Reviewed for Code Compliance
Permitting and Inspections Department
Approved with Conditions

PROTECTION PROFESSIONALS
DATE 8/8/19
REVISION: 1.0
66 MILLIKEN
NOVA ANALYTICS
SCALE: NS
SHEET: 1 OF 3
DESIGNER: PROTECTION PROFESSIONALS

NOVA
ANALYTIC
LABS
66 MILLIKEN
STREET
PORTLAND,
ME 04103

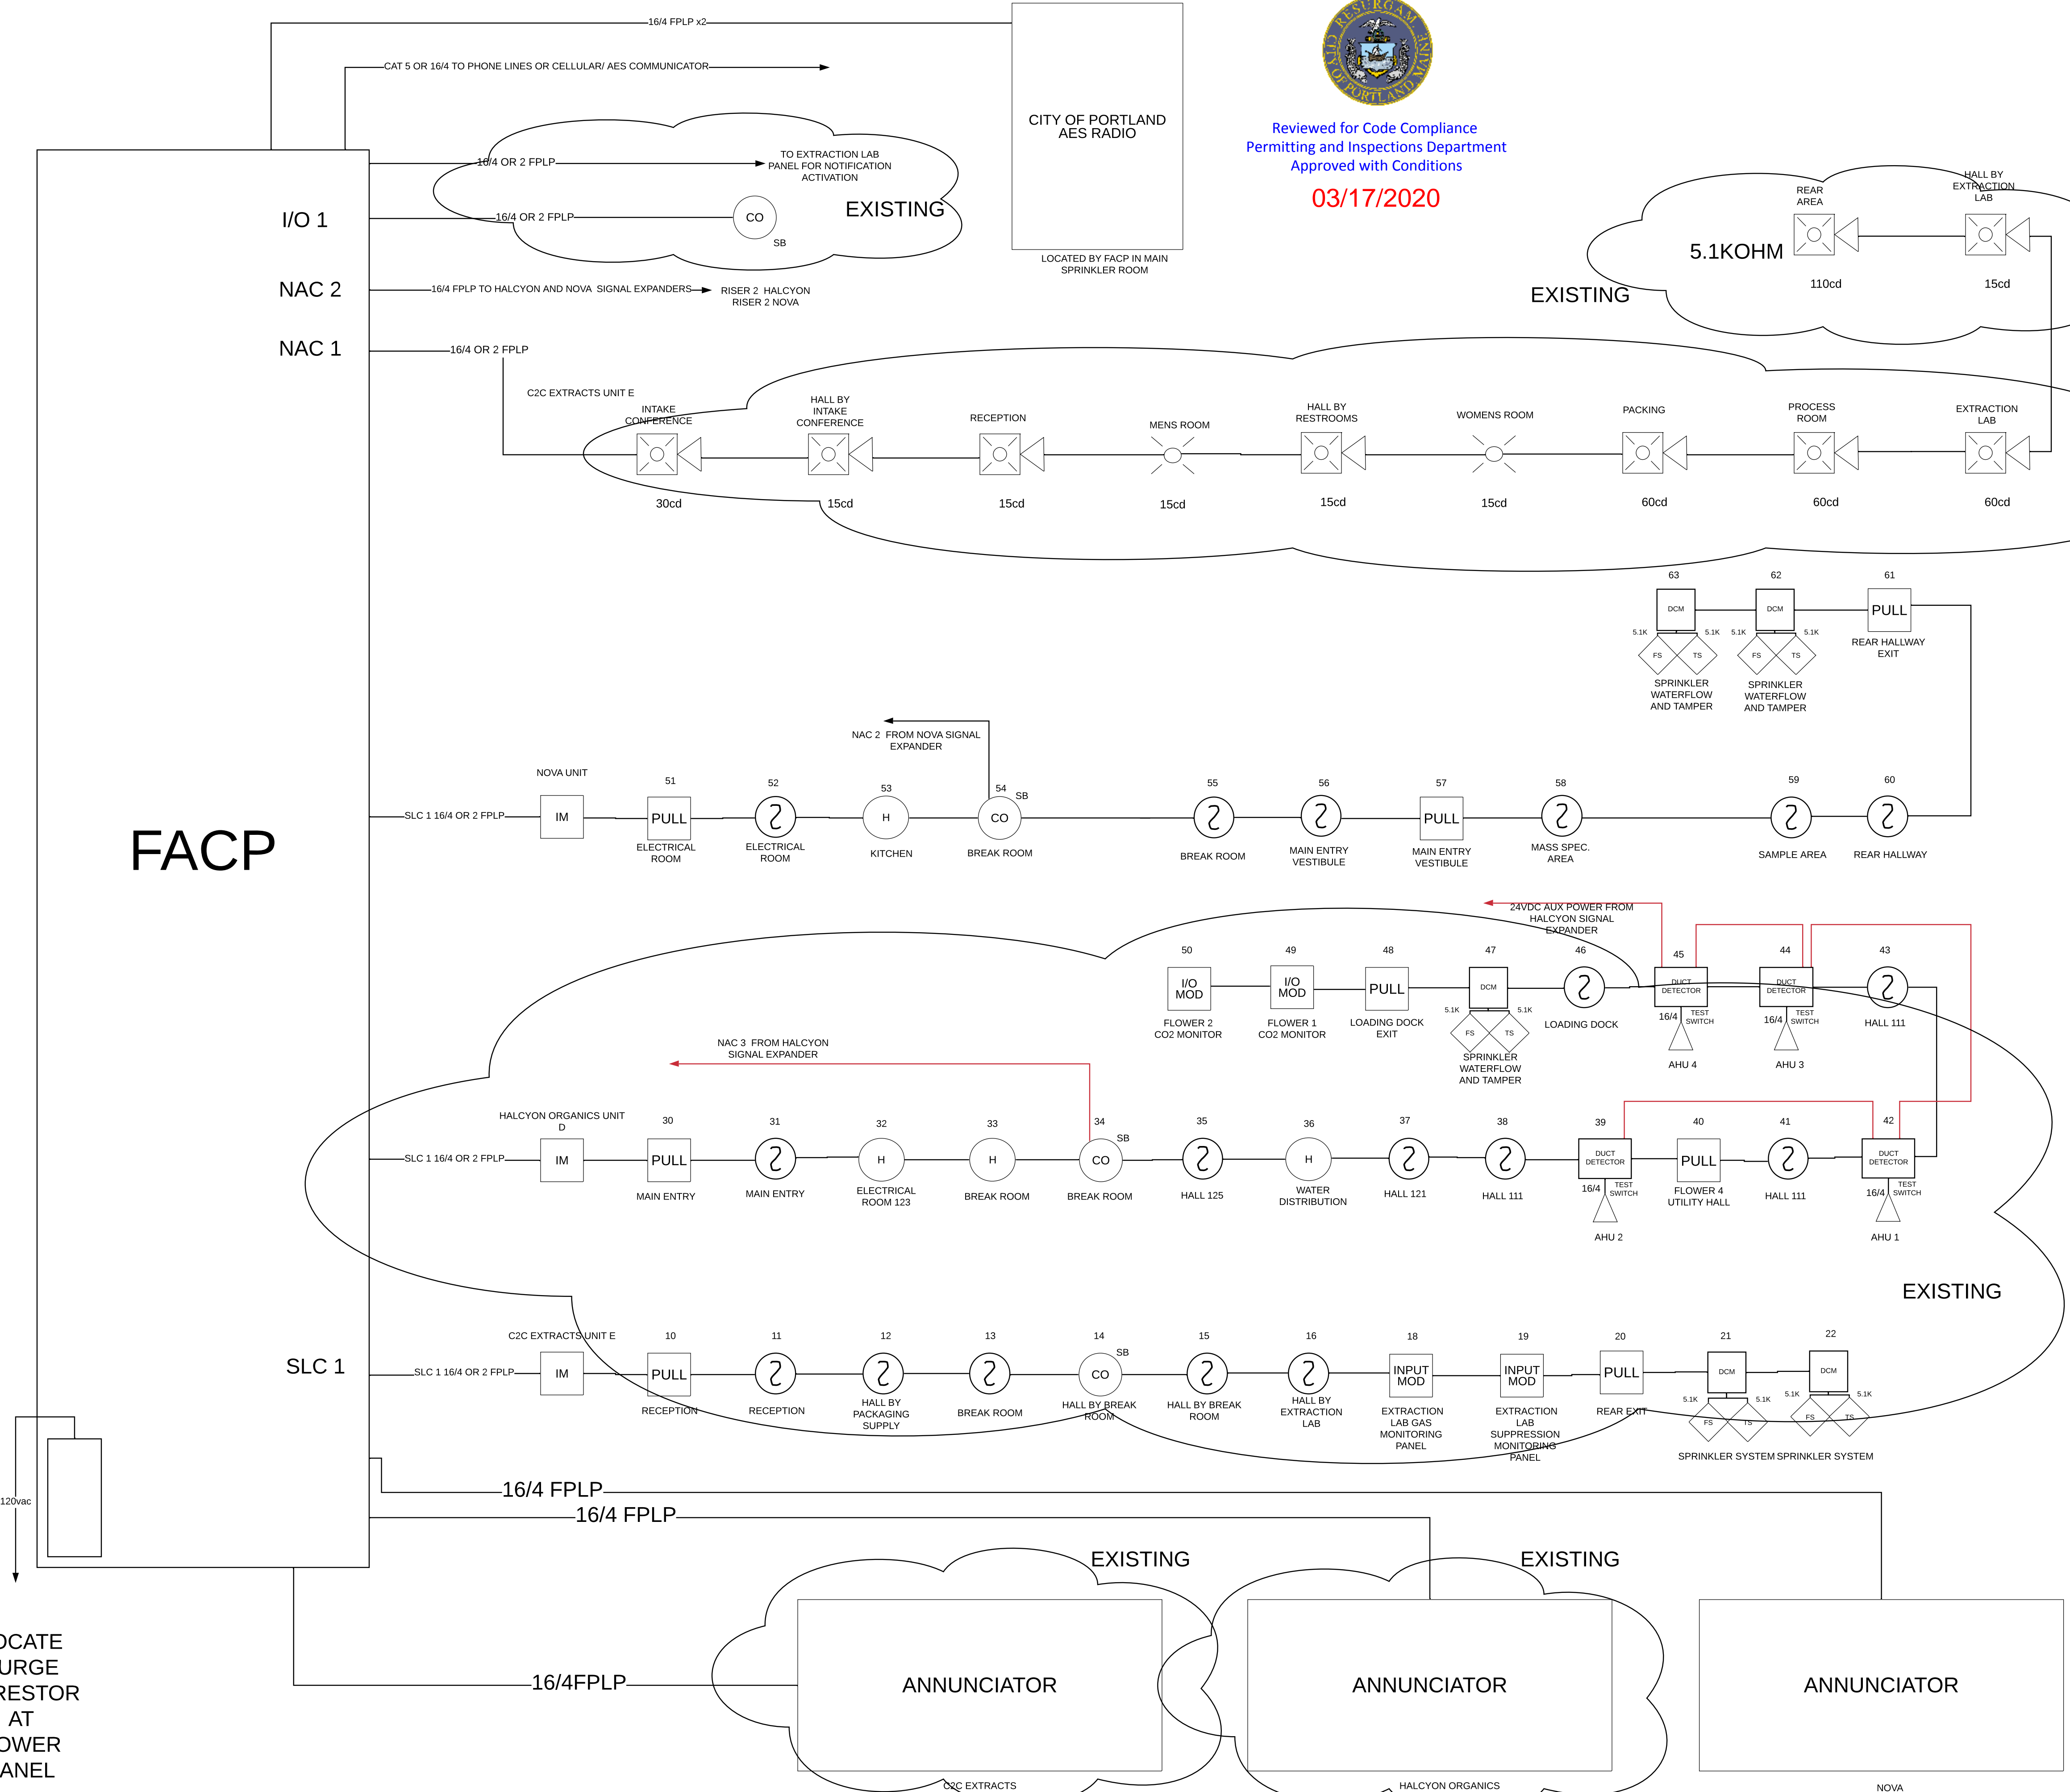
LOCATE SURGE ARRESTOR AT POWER PANEL

SHEET: 3 OF 3

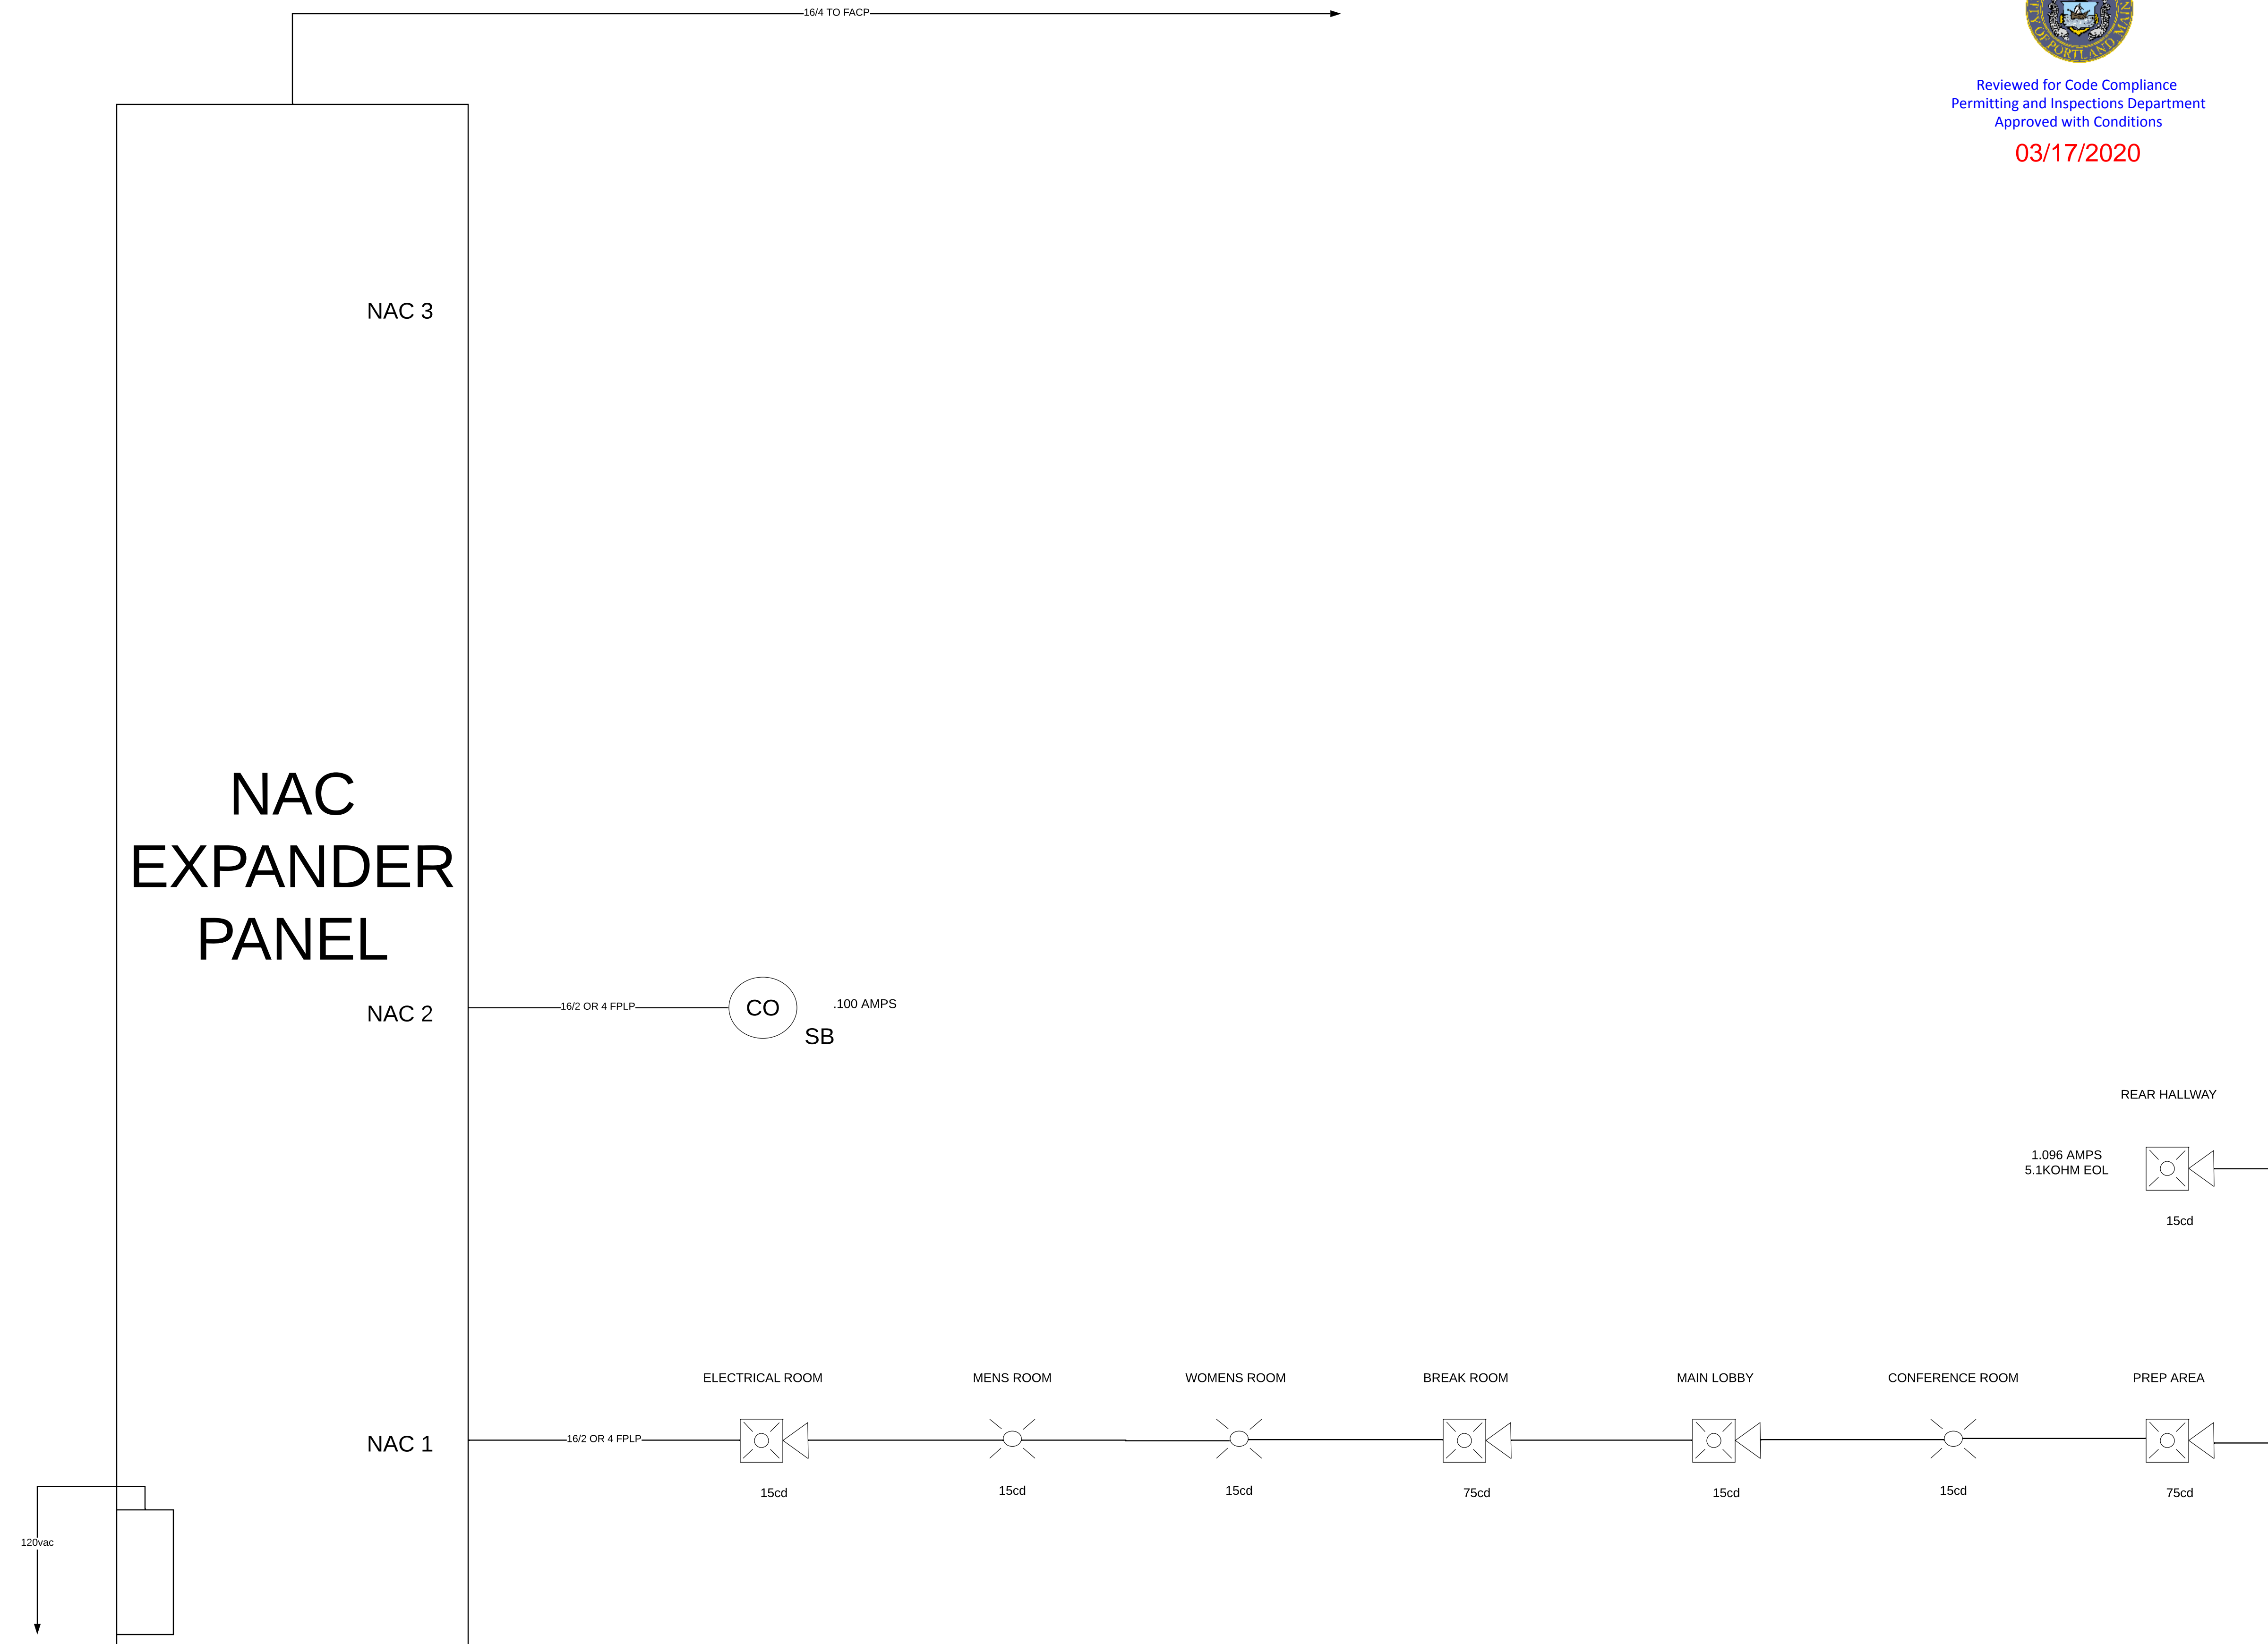
LOCATE
SURGE
ARRESTOR
AT
POWER
PANEL
